COMMUNITY DEVELOPMENT DEPARTMENT

SUBJECT: FP-2021-0032
Apex Southeast No. 2

Final plat consisting of 78 single-family residential buildable lots and 21 common lots on 20.34 acres of land in the R-8 zoning district.

B. Final Plat (dated: 4/9/21)

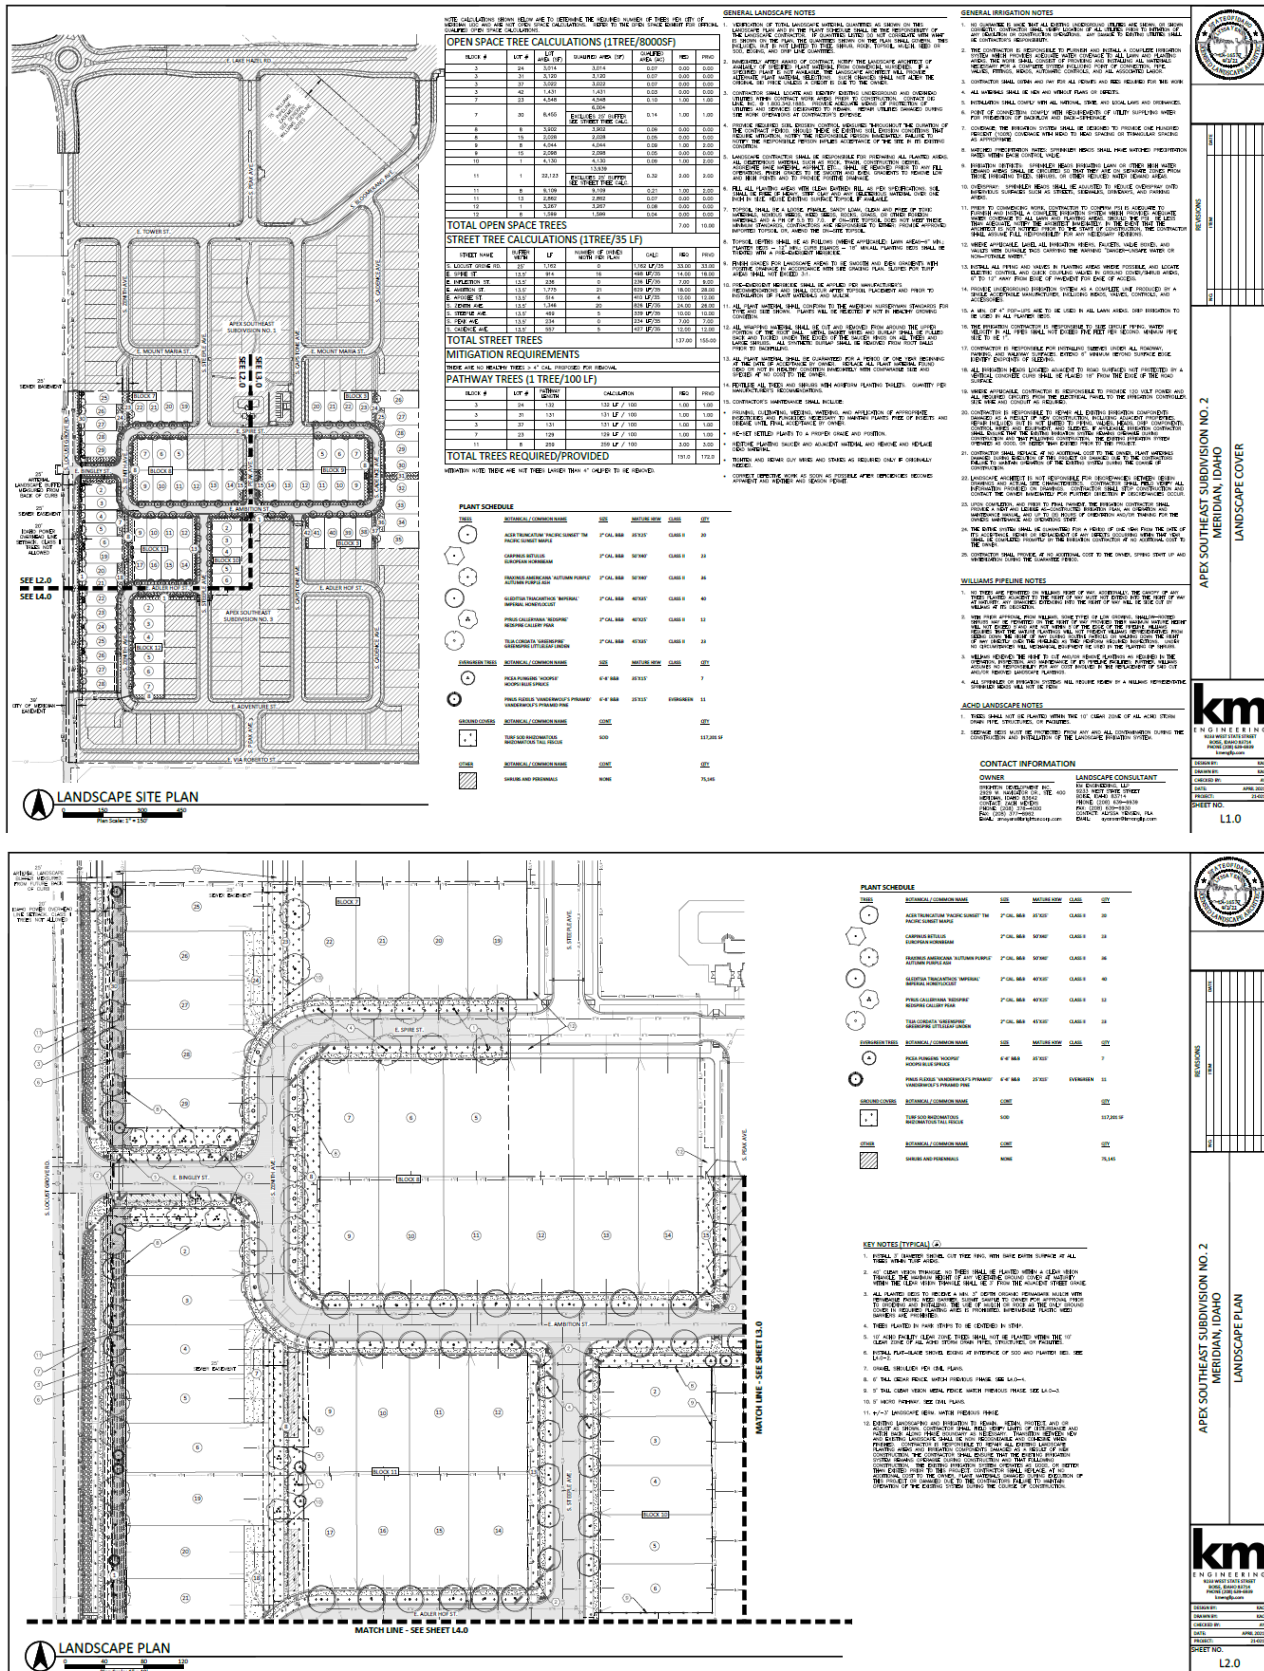
1. Applicant shall comply with all previous conditions of approval associated with this development (H-2020-0057; Development Agreement Instrument Number 2020-178120).
2. The applicant shall obtain the City Engineer's signature on the subject final plat within two years of the City Engineer's signature on the first phase final plat; *or* apply for a time extension, in accord with UDC 11-6B-7.
3. Prior to submittal for the City Engineer's signature, have the Certificate of Owners and the accompanying acknowledgement signed and notarized.
4. The final plat prepared by KM Engineering stamped by Aaron L. Ballard, dated: 4/9/2021, included in Section V.B shall be revised as follows:

References (Sheet 1):

- a. R1 – Include the Book and Page numbers of the Apex Southeast Subdivision No. 1 plat.

Notes (Sheet 3):

- b. Note #6: Clarify the last sentence of this note. It appears that "6." is misplaced.
- c. Note #10: Include the recorded instrument number of the ACHD landscape license agreement.
- d. Note #11: Include the recorded instrument number of the ACHD public right-of-way easement.
- e. Note #12: Strike note (not in this phase)
- f. Note #13: "Direct lot or parcel access to S. Locust Grove Rd. ~~and E. Lake Hazel Rd.~~ is prohibited. . ."
- g. Note #16: Does Lot 1, Block 11 contain the referenced easement? If not, delete.
- h. Note #17: Include the recorded instrument number of the CC&R's.

A copy of the revised plat shall be submitted with the final plat for City Engineer signature.

D. Common Driveway Exhibits

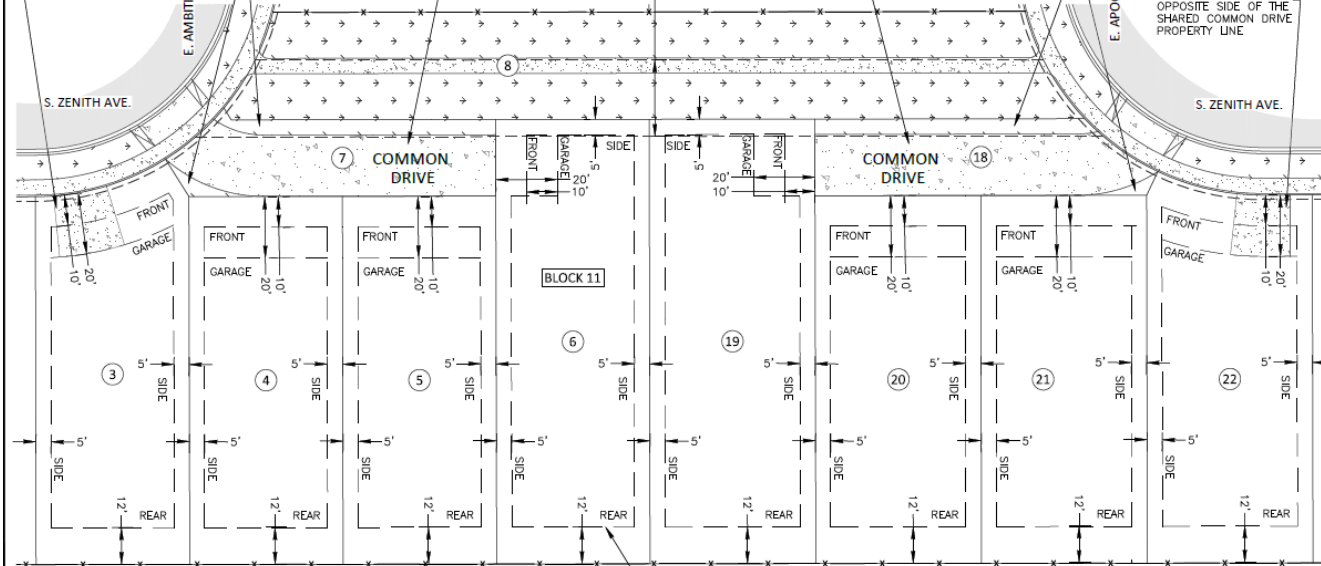
13. The setbacks and/or driveway locations for lots accessed via common driveways or abutting common driveways shall be as shown on the exhibit in Section V.D (applies to Lots 26-28 and 33-35, Block 3; Lots 25-28, Block 7; Lots 3-6 and 19-22, Block 11).
